Final Remedial Construction Report AOC 3

**Iron Horse Park Superfund Site
Operable Unit 3, Billerica, MA**

19 November 2020

On behalf of Pan Am Railways (Pan Am), Environmental Resources Management (ERM) is submitting a field revision to the AOC 3 landfill design presented in the approved AOCs 1, 2, and 3 Final Design Report, and dated 24 September 2012. This revision is prompted from encountering refusal at a shallower depth while driving sheet pile in a localized segment in AOC 3A. Specifically, this modification is requested for AOC 3A for the following:

A03 TYPICAL SHEET PIPE WALL DRAIN PIPE CLEANOUT DETAIL
NOT TO SCALE

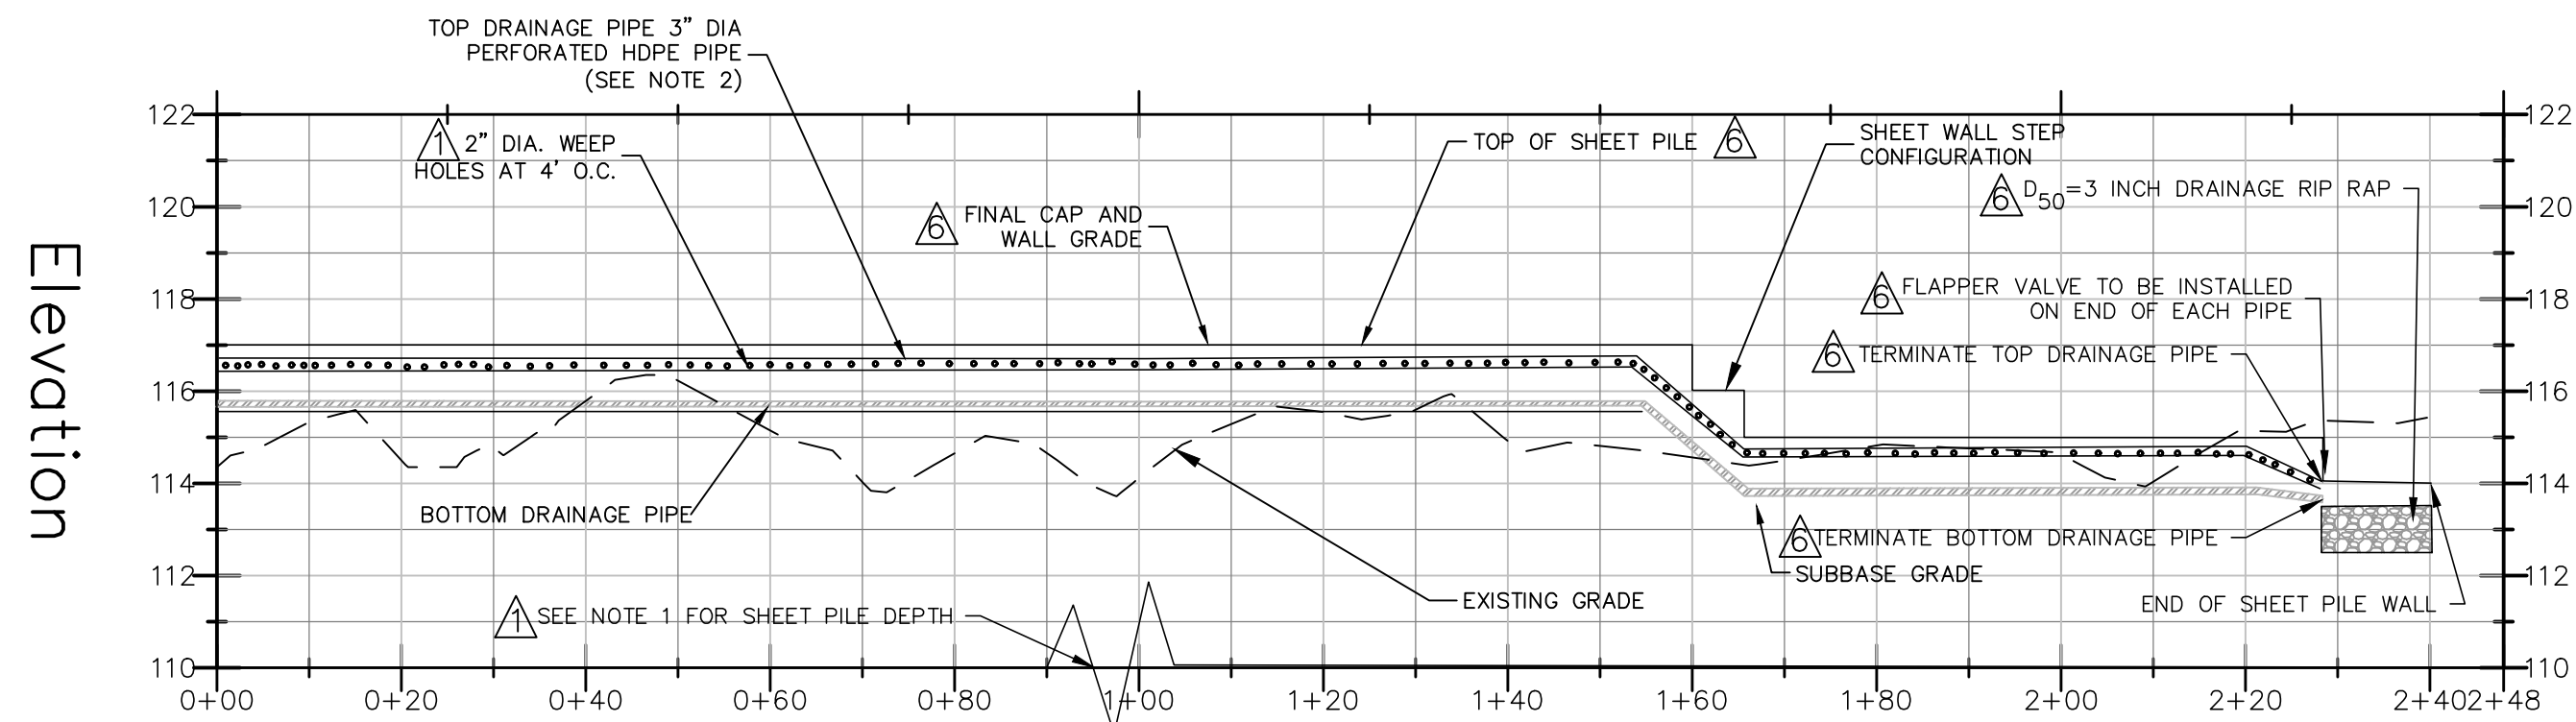
- NOTE:
1. THE 3" DIA DRAINAGE PIPE SHALL INSTALLED AS LOW AS POSSIBLE ABOVE THE GEOMEMBRANE BUT SHALL NOT BE INSTALLED BELOW THE ELEVATION OF 113.75 ASML.
 2. THE WEEP HOLES SHALL BE LOCATED IN THE CENTER 1/3 OF THE SHEET PILE WEB, NOT THROUGH THE INTERLOCK. THE CONTRACTOR MAY NEED TO FIELD ADJUST THE LOCATION OF THE WEEP HOLES, ACCORDINGLY, WITH PRIOR APPROVAL FROM ENGINEER.
 3. THE CONTRACTOR SHALL INSTALL THE WEEP HOLES HYDRAULICALLY THROUGH THE SHEET PILE. ALTERNATIVE METHODS SHALL BE SUBMITTED AND APPROVED BY THE ENGINEER.

Step 1: Plastic Bag Removal

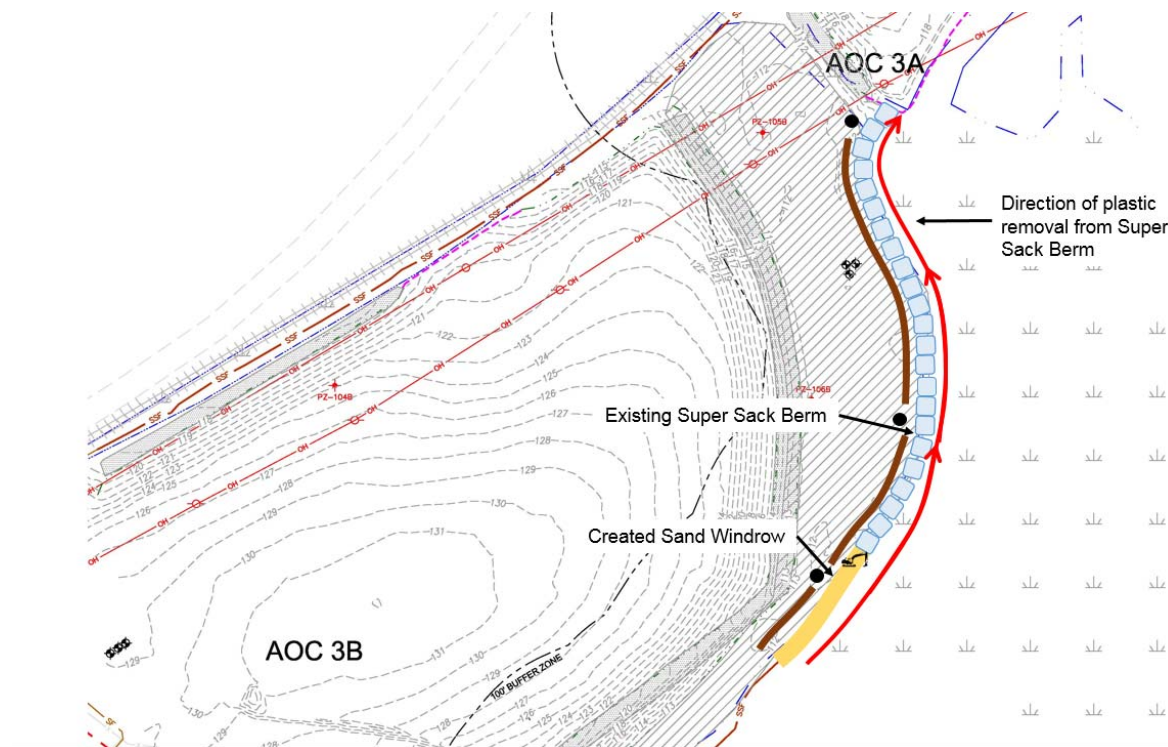
Beginning at the Southeastern end of the Super Sack berm on AOC 3B, Charter will lift the plastic Super Sacks using the forklift straps and a mini excavator then cut the closeable spout on the bottom for slow and controlled material discharge. The plastic layer will be fully removed, leaving the sand in place as an elevated windrow. The excavator will use this windrow as a pathway to move northward across the wetland, removing Super Sacks one by one. A sketch of this is provided below:

Step 2: Sump Removal

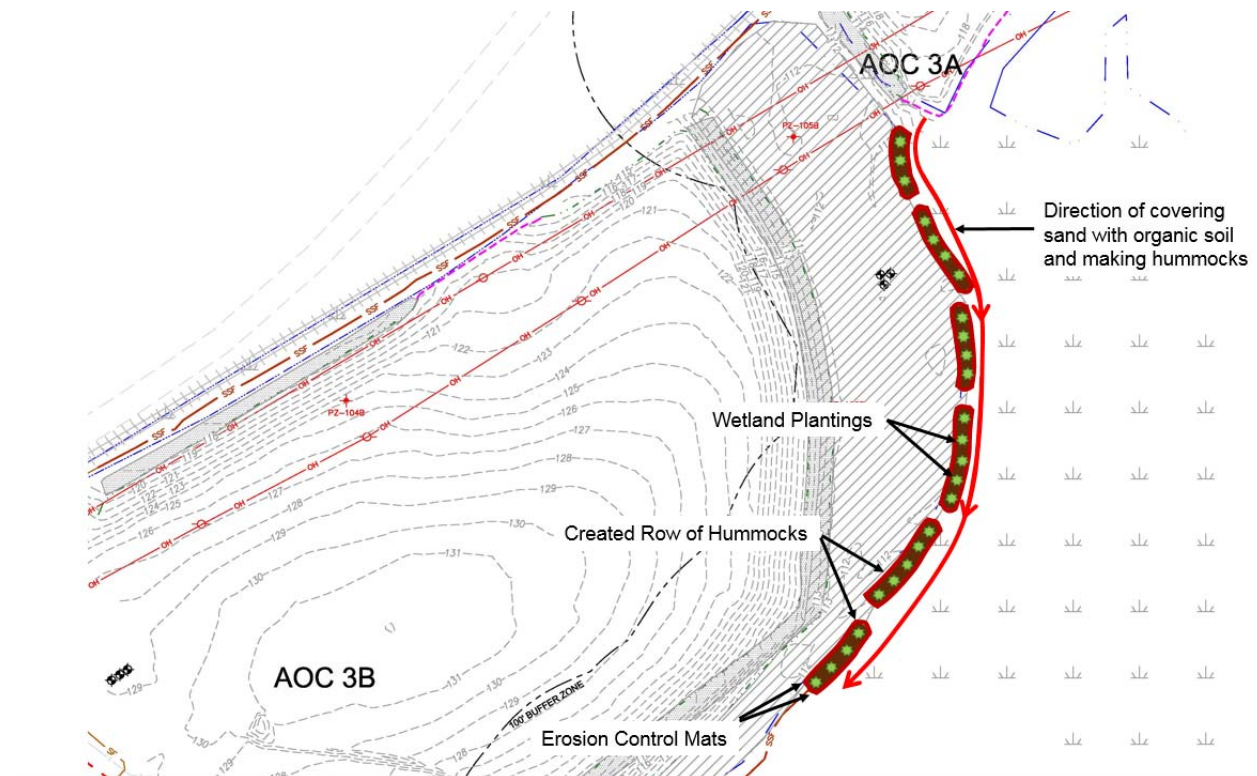
Once all plastic Super Sack wrapping has been removed and sand contents placed, all remaining sumps will be removed from the wetland and the area restored. The sand windrow will again be used as an access pathway to complete this work.

Existing Wetland

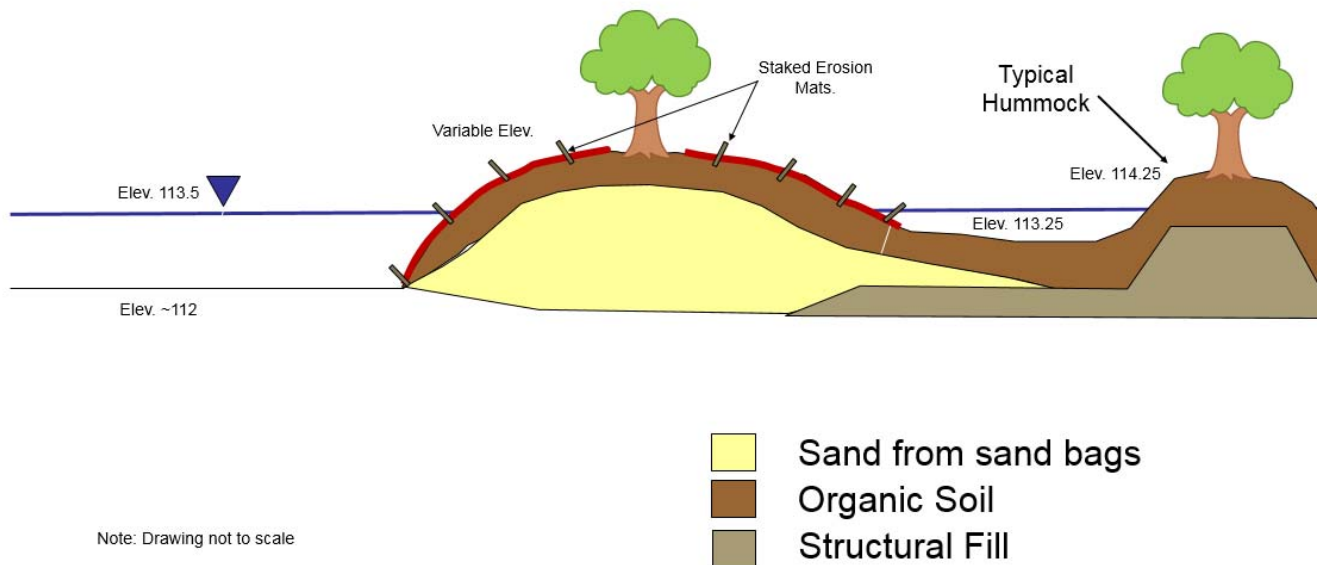
The sand windrow will be shaped into hummocks approximately 50 feet in length, separated by gaps approximately 10 feet wide. These low points will allow for hydraulic continuity between the existing and restored wetland areas. The final hummocks will be variable in height (114-116 AMSL) and length to mimic natural conditions and potentially mitigate the spread of *phragmites australis* into the restoration area through the use of plantings that provide shade. A cross section and plan view sketch of this are provided below:

AOC 3 WETLAND RESTORATION PLAN

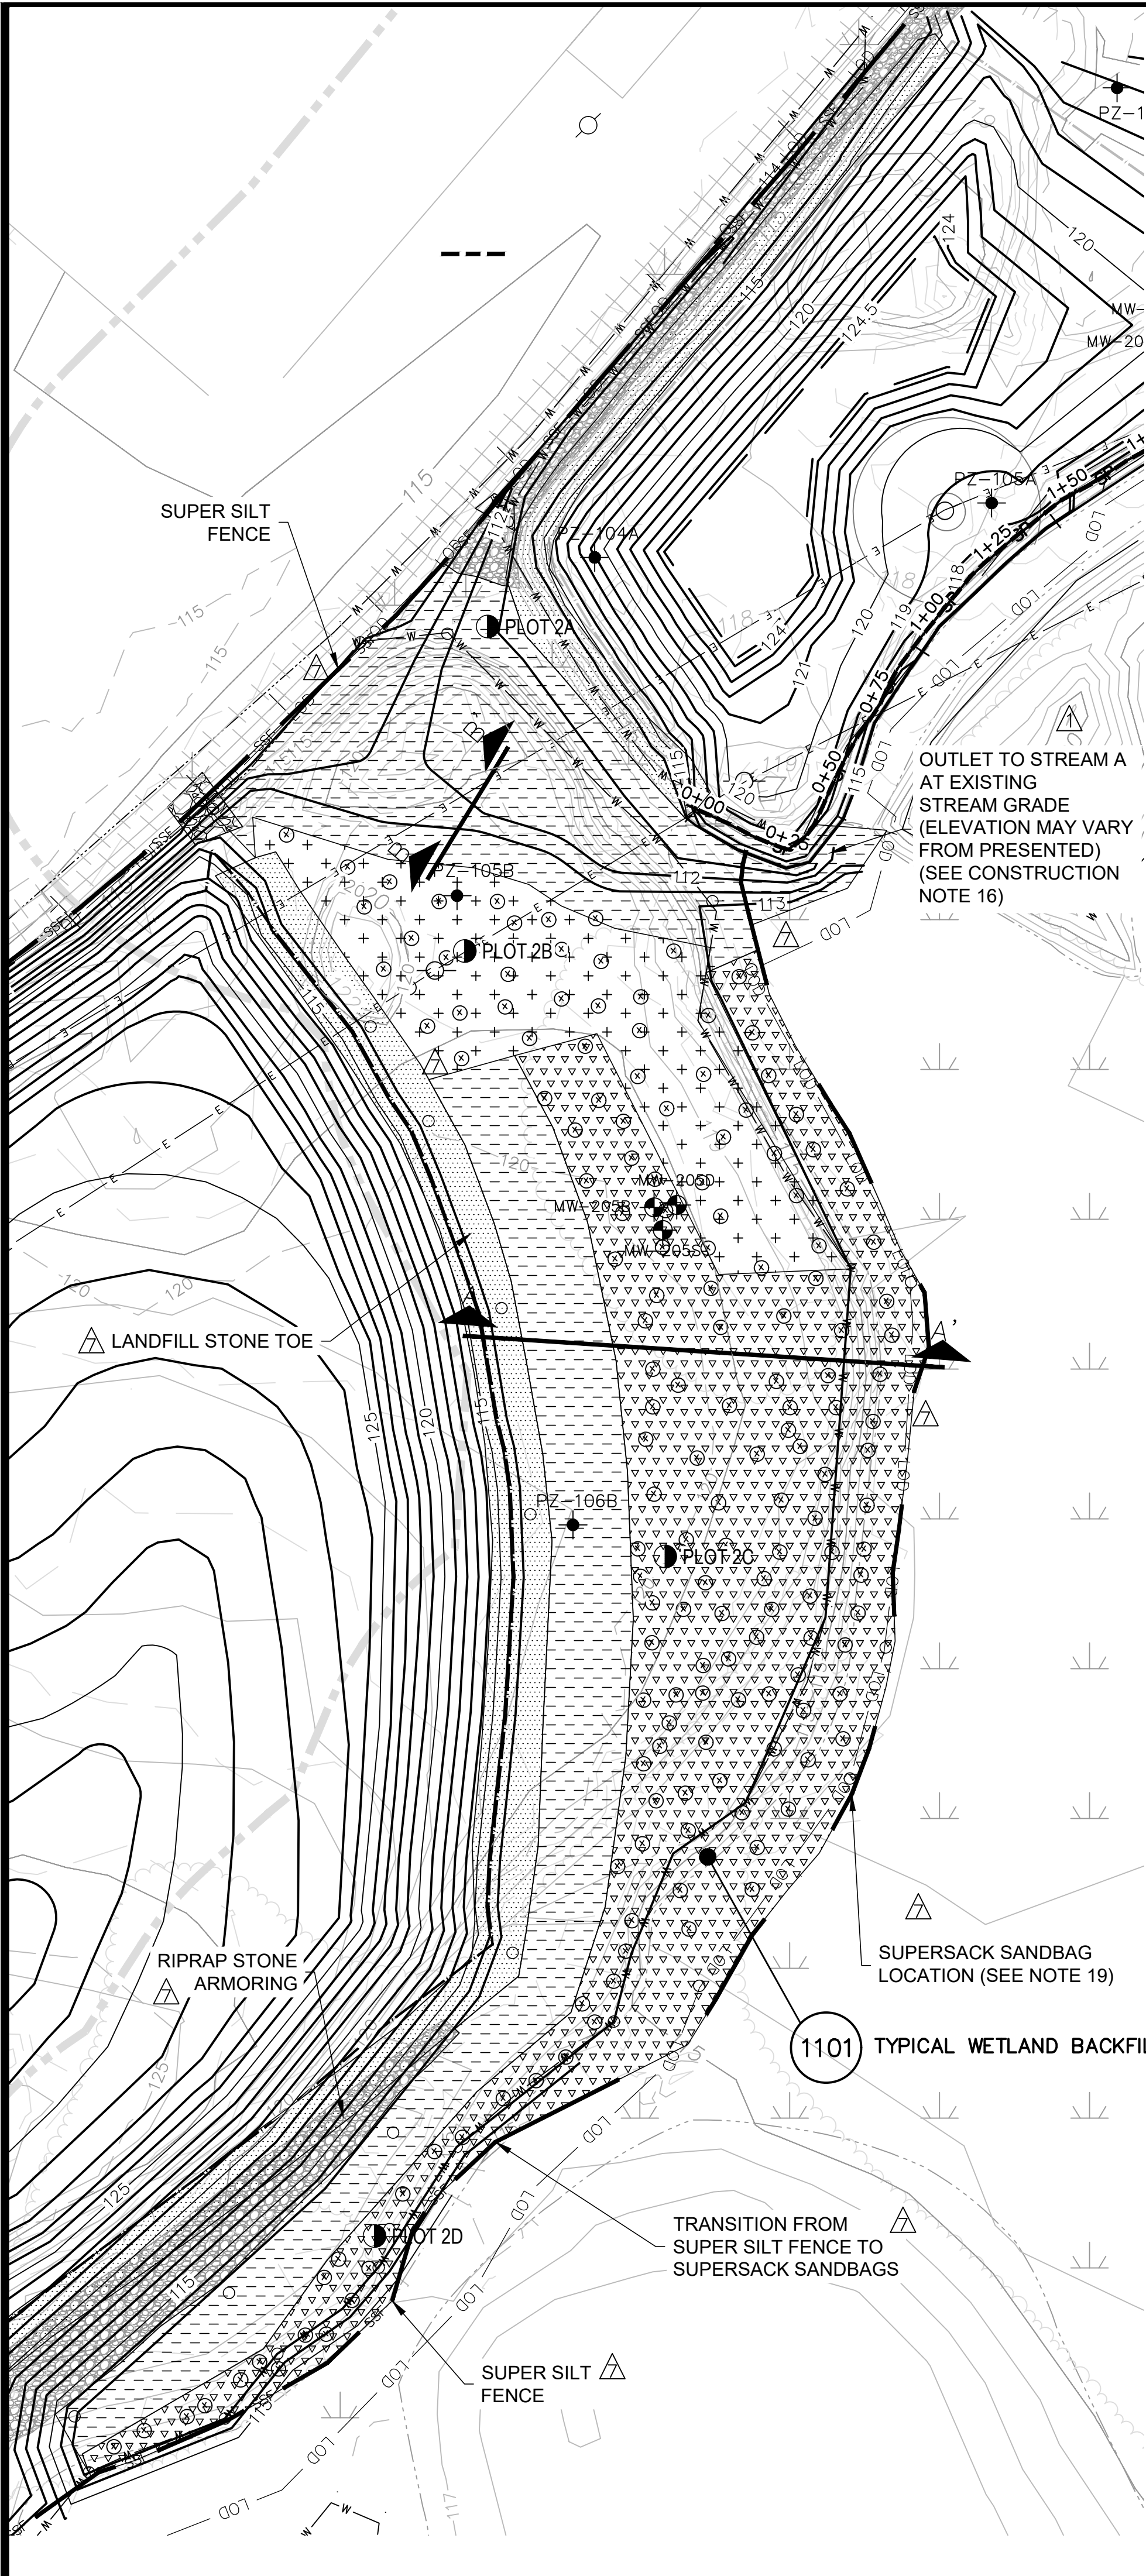
To incorporate the forested wetland being added to the restoration design, some updates were made to the layout of the wetland zones provided in the final design. These updates included switching the easternmost edge from a classification of palustrine emergent (PEM) to palustrine forested (PFO). The seeds and plants specified to PEM and PFO has remained the same, but their physical location has been adjusted as shown on the updated drawing. Switching the zones will both utilize the sand within the super sand bags in hummock construction, as well as create a denser buffer along the outer boundary of newly created wetlands.

In particular, the existing wetland is observed to be predominantly vegetated with *phragmites*. Providing PFO species and their desired subsequent shading will assist in preventing the *phragmites* from out competing the hydrophytic plantings and seed species.

As shown on the updated drawings, the PEM has been moved to the westernmost edge of the created wetland area/toe-of-slope of AOC 3B to maintain the same square footage as originally designed. Maintaining the same square footage is important, as those areas and mitigation ratios were approved when permitting the project with the U.S. EPA and account for the balance of wetland mitigation required for AOCs 1, 2, 3, and 6. If any further adjustments are made or field directed, it is crucial to maintain at least the amount (if not greater) the square footage of the original design of PFO and PSS. PFO and PSS have lower succession rates than that of the PEM areas.

The original palustrine scrub-shrub (PSS) area has remained unchanged from the original design. The PEM designated area located in the northern portion adjacent to AOC 3A has also remained unchanged from the original design.
